**CITY OF CHESTERFIELD
PLANNING AND PUBLIC WORKS COMMITTEE MEETING**

**THURSDAY, AUGUST 20, 2026
5:30 P.M.**

RE: **Hilltown Village Lot 2 (Good Clean Dog):** An Amended Site Development Section Plan, Landscape Plan, Lighting Plan, and Amended Architectural Elevations for part of a 2.56-acre tract of land located at the intersection of Hilltown Village Center and Olive Boulevard.

Volz, Inc., in partnership with Mademan Design, LLC, and on behalf of Good Clean Dog Chesterfield, LLC, submitted an Amended Site Development Section Plan, Landscape Plan, Lighting Plan, and Amended Architectural Elevations for the redevelopment of an existing structure on a portion of a 2.56-acre tract at the intersection of Hilltown Village Center and Olive Boulevard, in preparation for converting the site from a childcare facility to a dog grooming facility.

ELEVATIONS

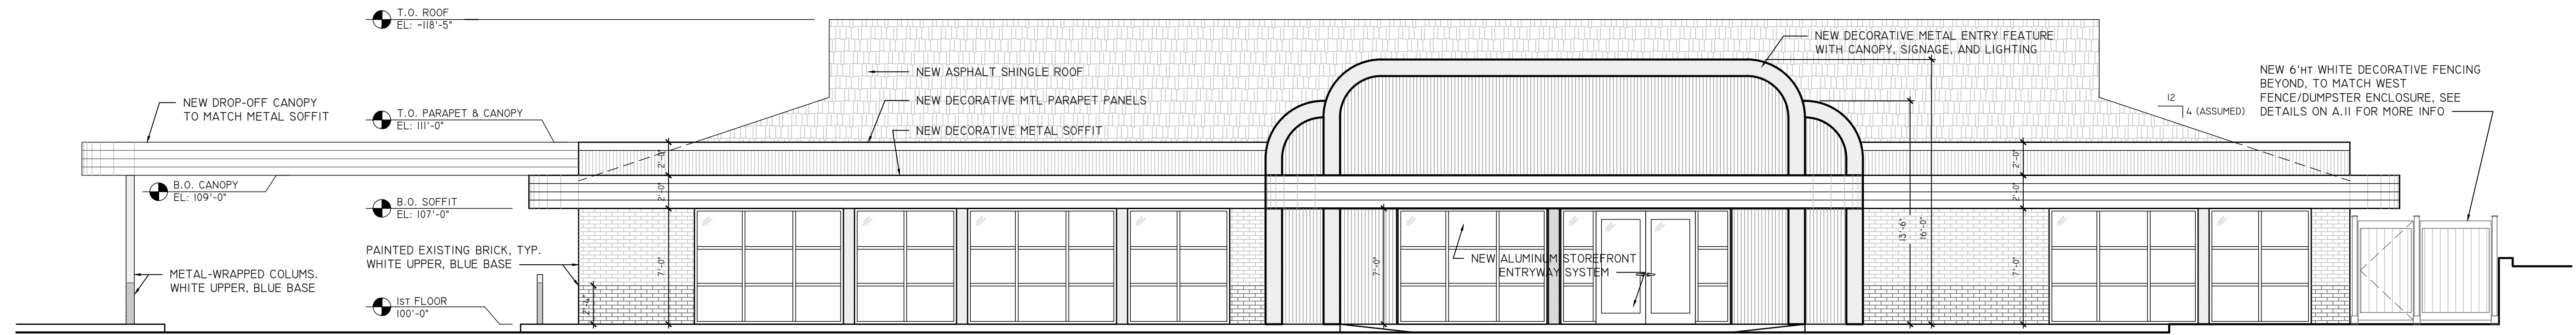
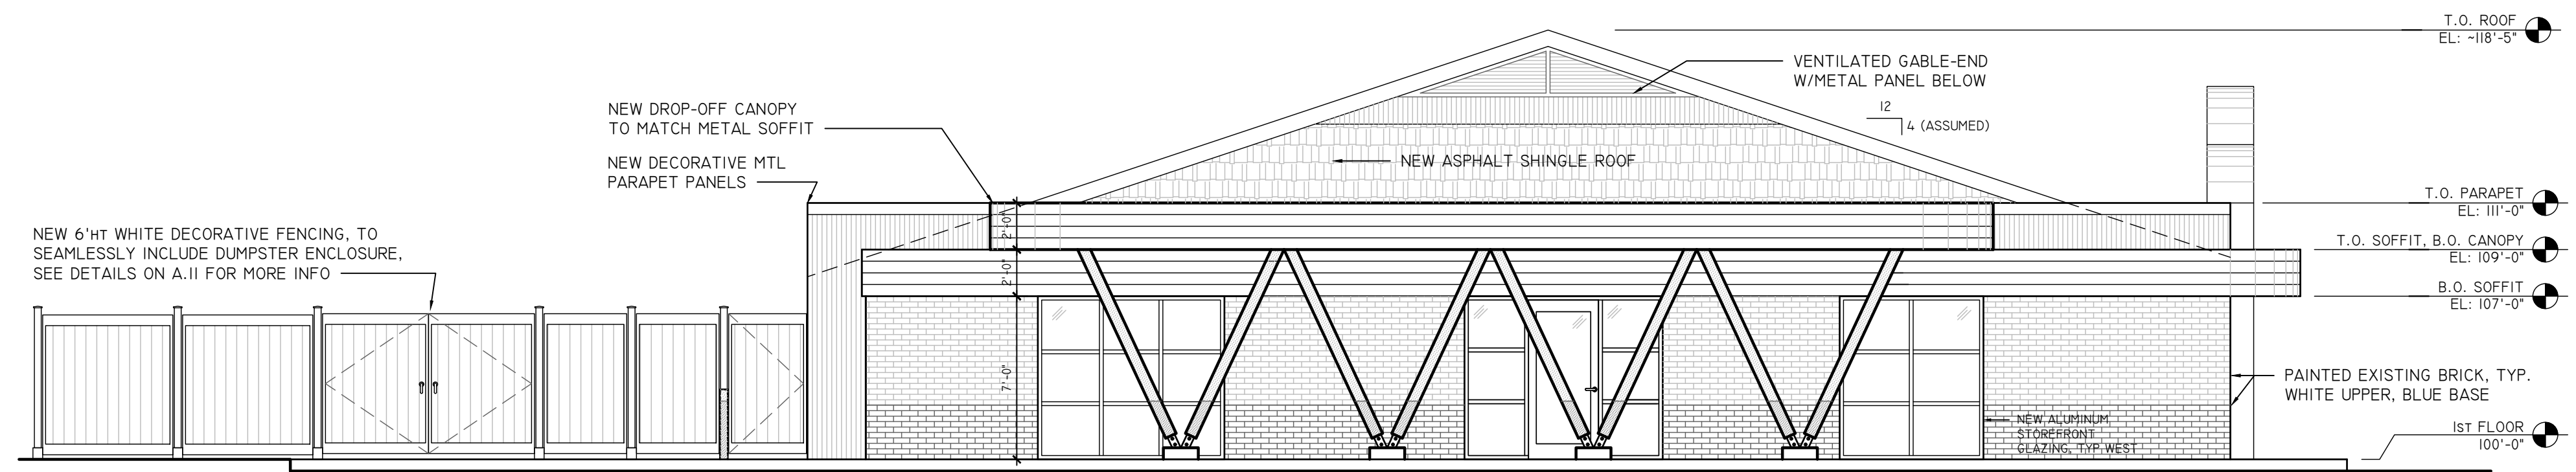
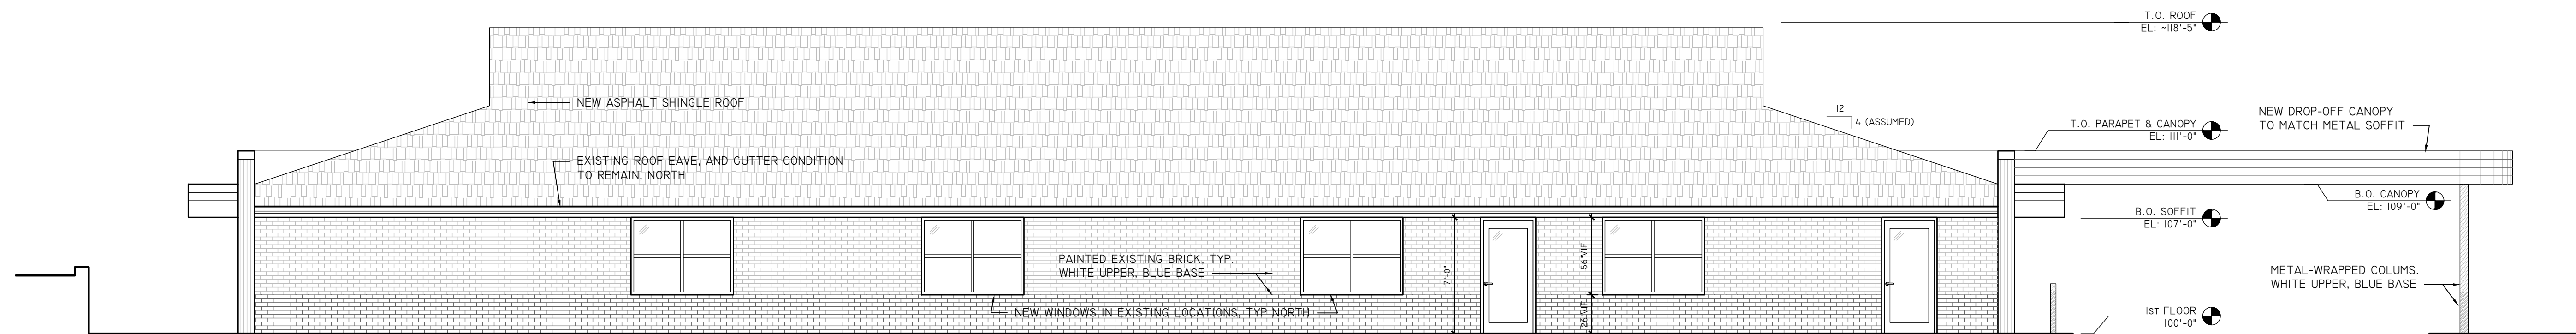
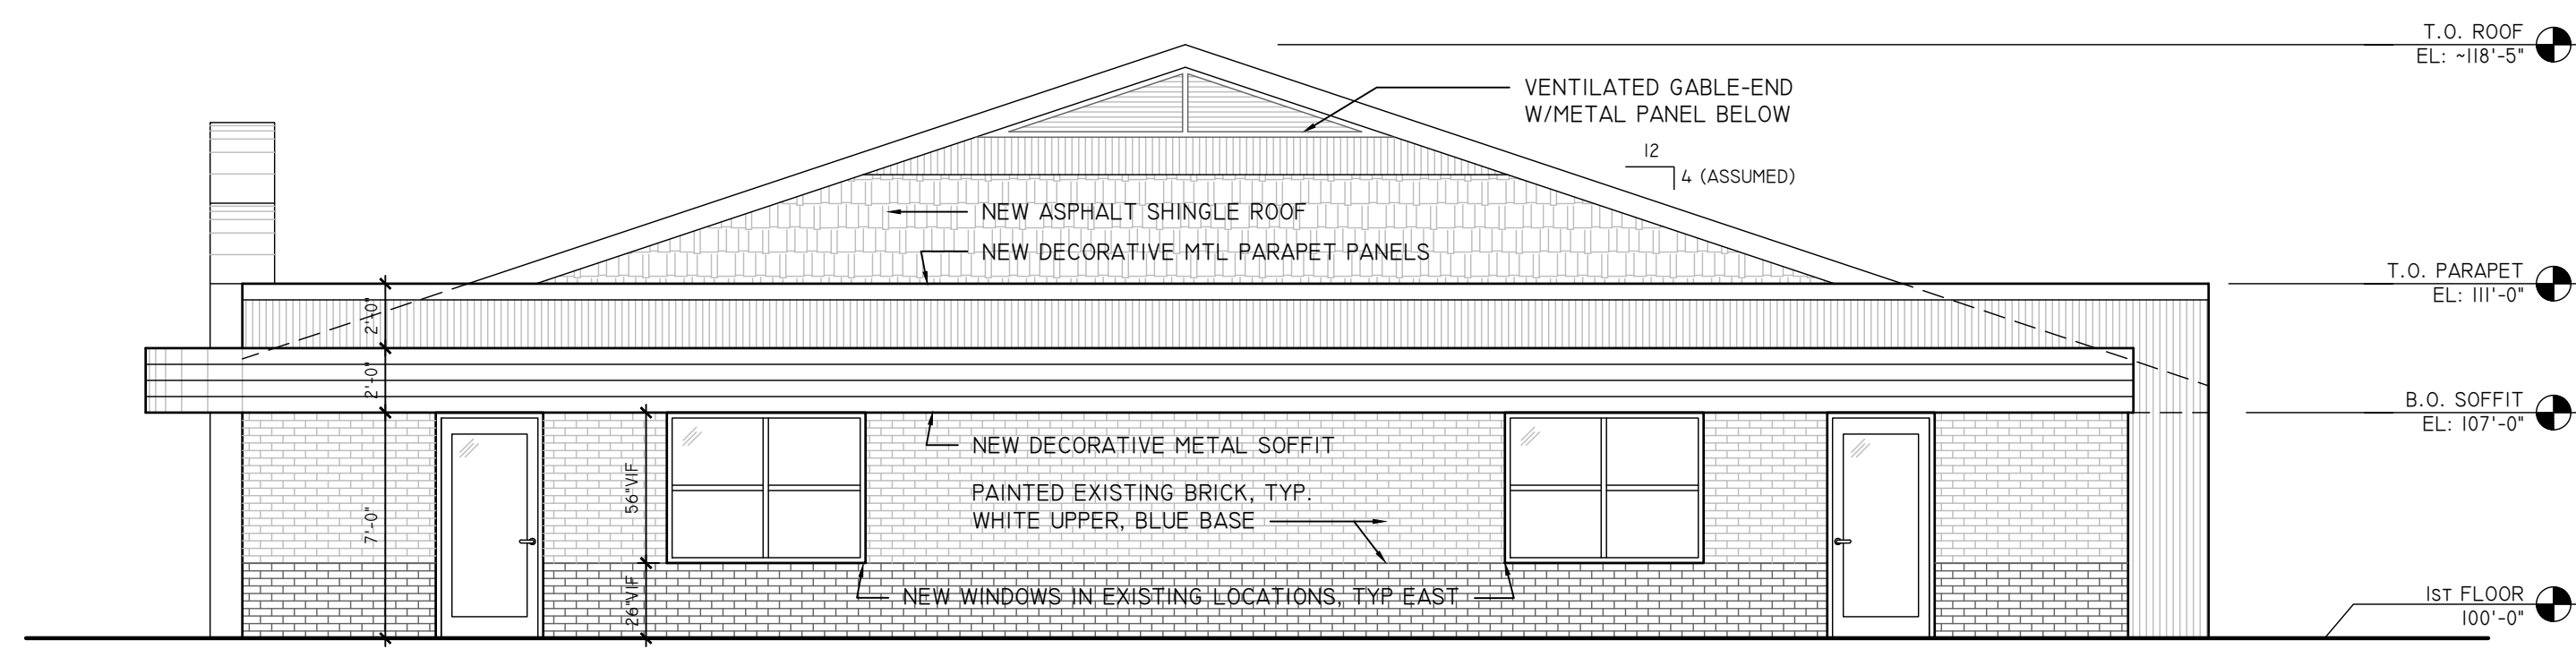
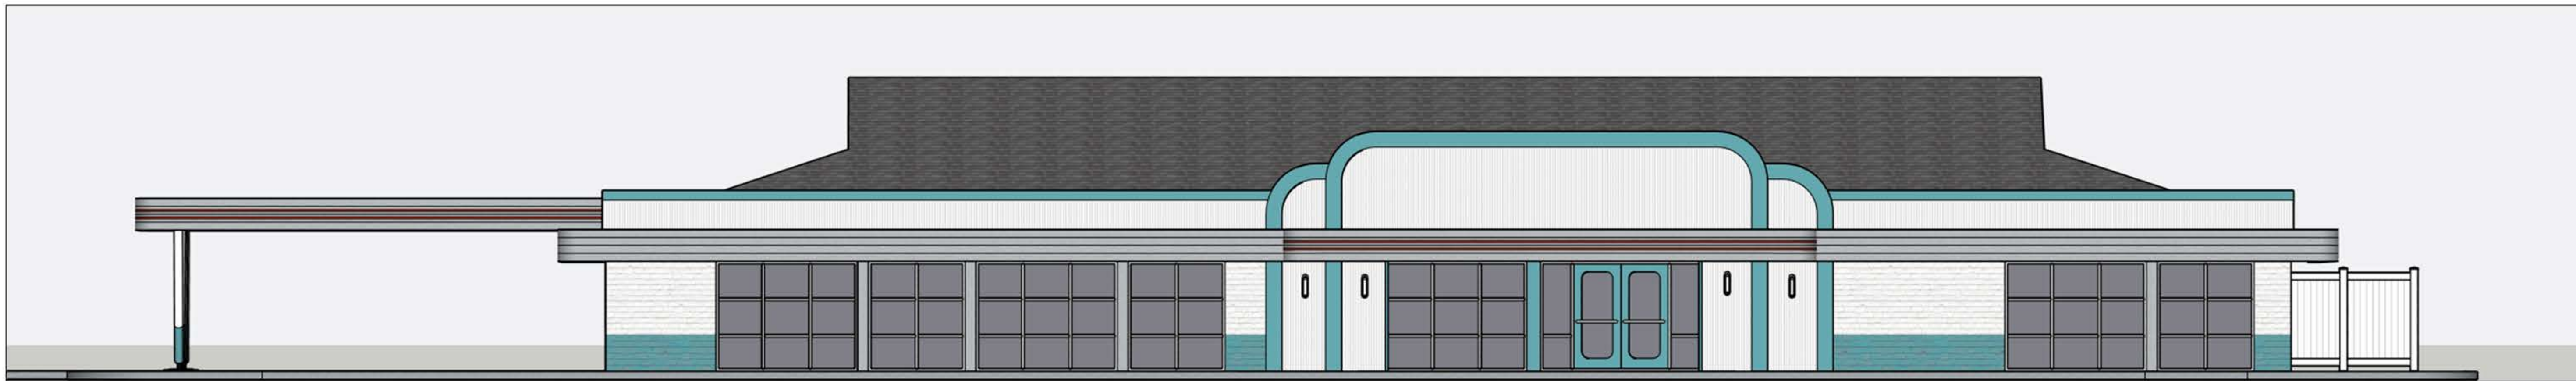
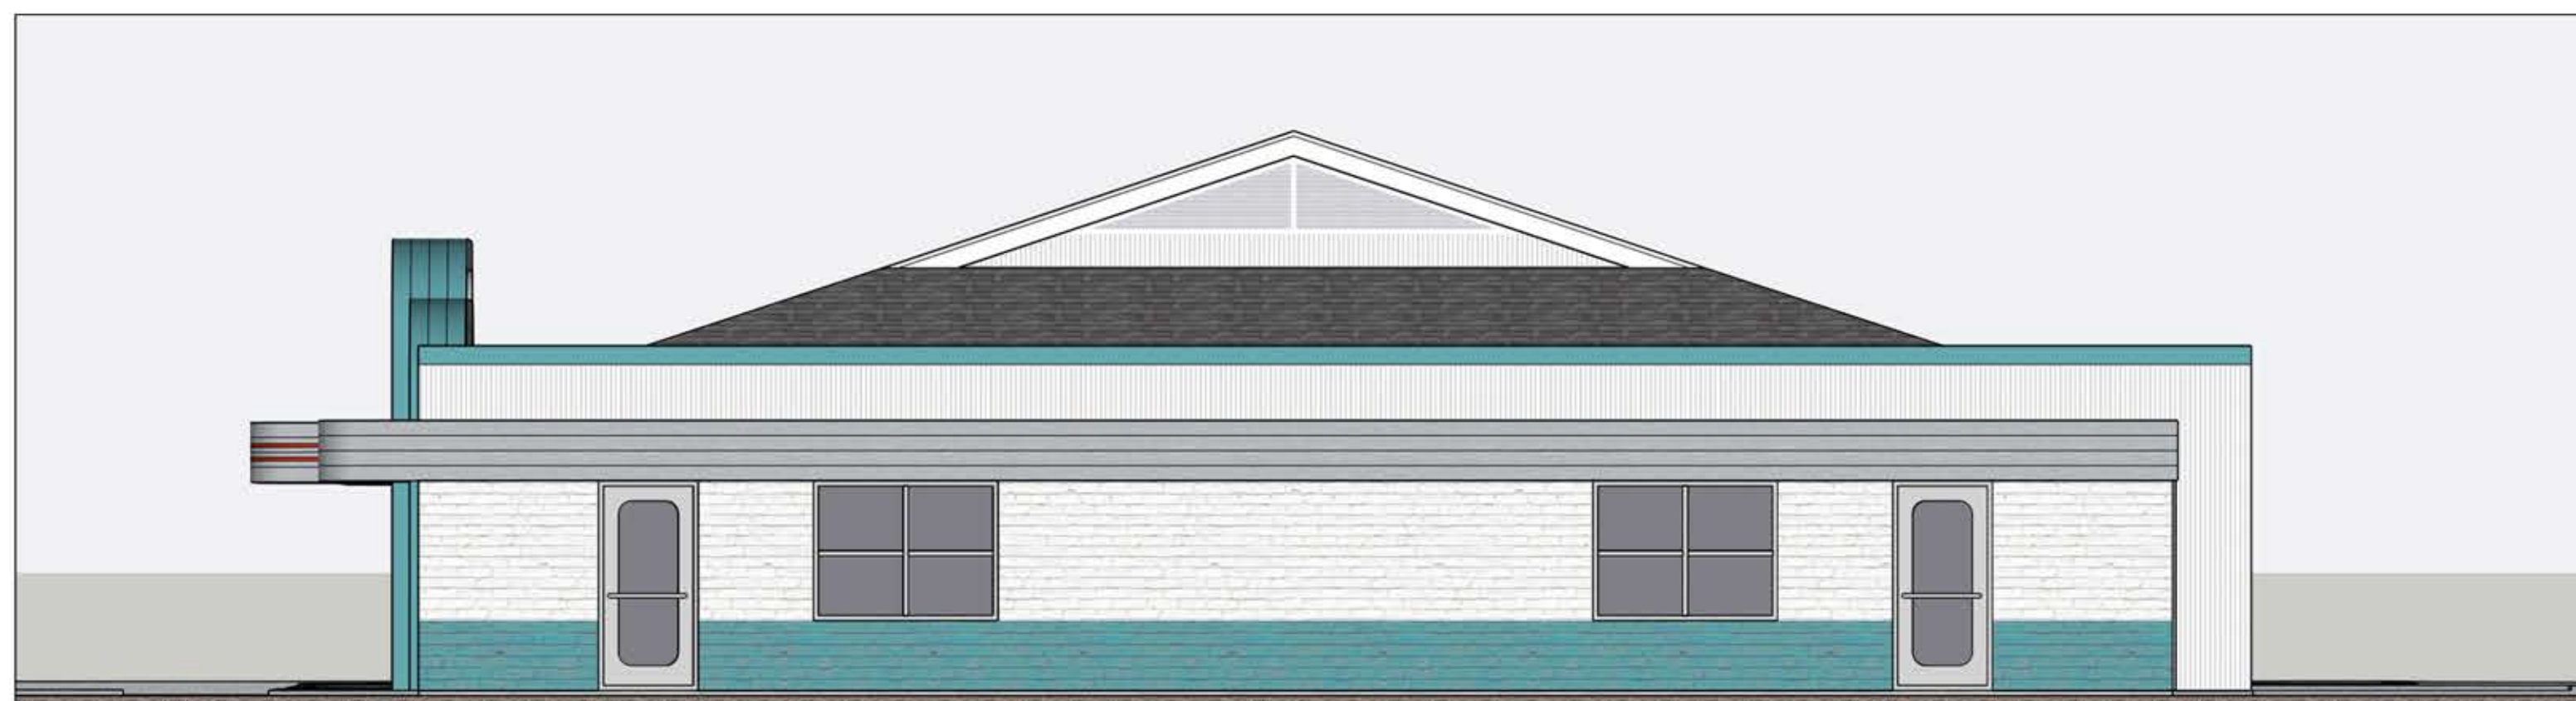
1. Remove the red LED rope lighting from the rear of the building facing the residential subdivision.
2. Provide updated nighttime renderings that reflect the full design, including the murals and graphics.

The applicant has since submitted revised elevations depicting the change in the rope lighting around the canopy, and provided a nighttime rendering depicting the murals and graphics. Upon review, the ARB had no objections to the proposed changes and additional samples.
